CAMPAIGN BULLETIN

05-586-09

Models Affected: HR37 & HR40 Aerials

SUBJECT: Rod Weldment of 437250D Main Lift Cylinder

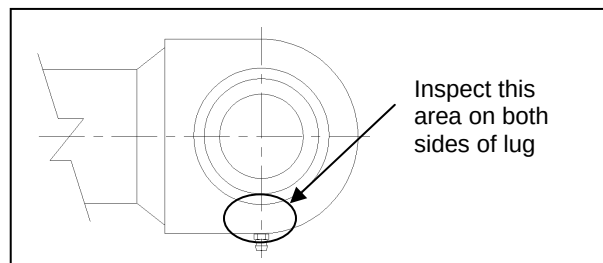
The owner or user must immediately perform a visual inspection of the cylinder rod eye in the area of the grease zerk. Clean off the dirt and grease to determine if a crack is evident near the ball bushing. If there are any indications of a crack remove the unit from service and contact Terex Utilities at 605-884-3892. If no cracks are detected contact the nearest Terex Utilities dealer to arrange replacement of the cylinder rod within 45 days. You may continue to use the unit if you inspect the rod eye daily to determine that no cracks are present.

Inspect Lift cylinder rod end in this area on both sides. Clean off dirt and grease to see side of lug down to the bushing bore.

Affected units, as shown on the owner letter, will have the cylinder rod replaced at no charge to the owner. Repair parts will be available beginning 5/15/09. All 437250D cylinder rods with the date codes listed above will be replaced.
